Addendum No. 1 to ITB 2022-18

**CONSTRUCTION OF NEW LIFT STATION ON ALEXANDER ROAD AND
INSTALLATION OF NEW FORCE MAIN**

August 3, 2022

Page LS1

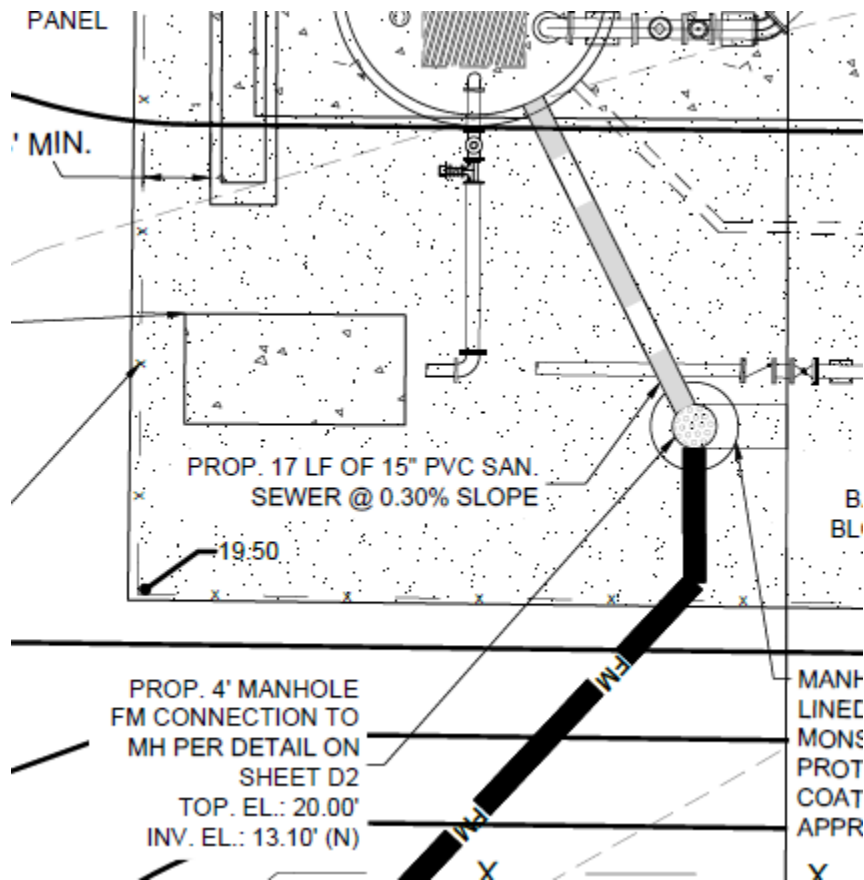
Q2. It appears that the same pipe is call out different size and % of grade for the connection from the MH to the Wet well.

(15" PVC on LS1 and 12" PVC on LS2)

A2. The correct pipe from the MH to the Wet Well is the 15" PVC SAN Sewer at .30% Slope.

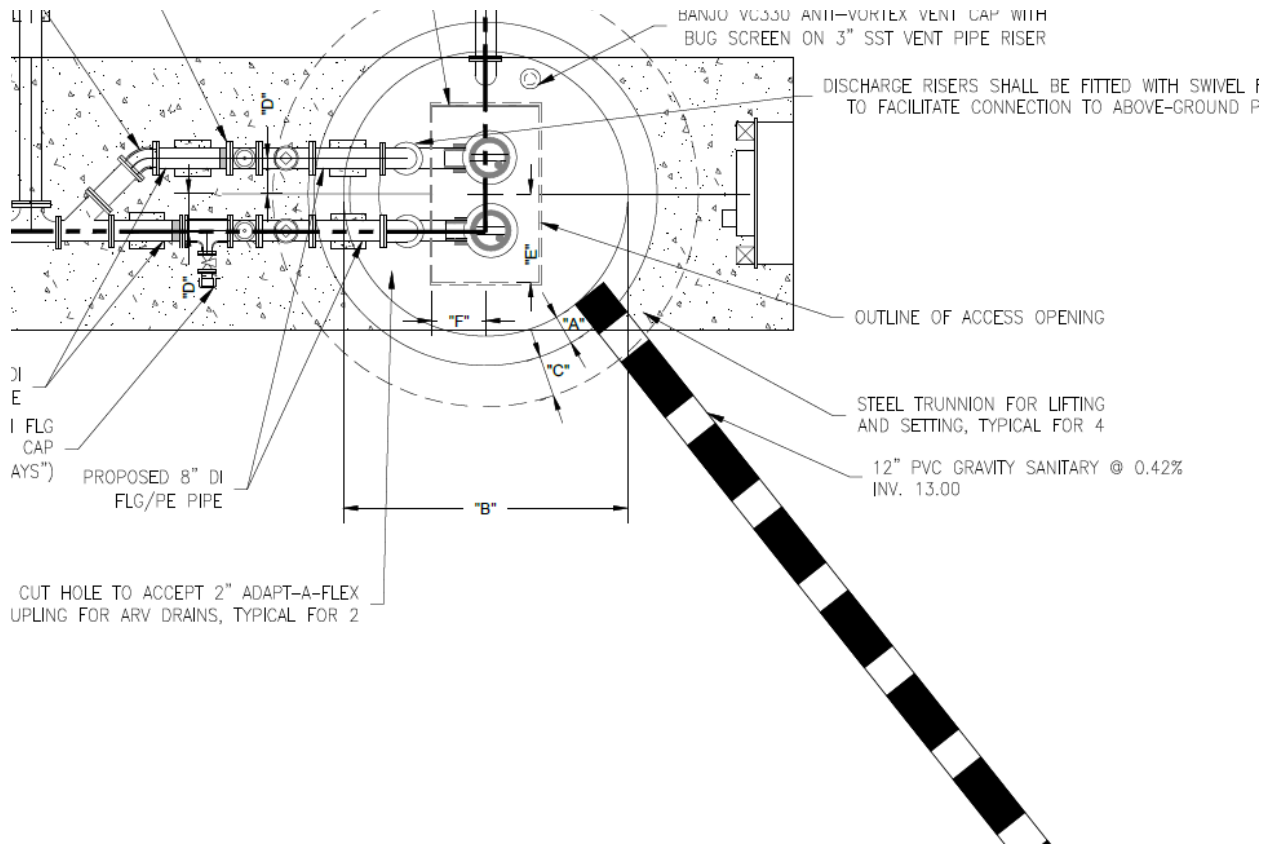
Q1. The plans show several 6" plugs and fittings on the existing force main, but there is no pay item for the plugs. Please provide further information.

A1. There are five 6" plugs, one on C-1.0, two on C-1.1, one on C-1.2, and one on C-2.2. As directed in C-1.0 use restrained MJ Caps. These five caps will be added to the bid sheet.
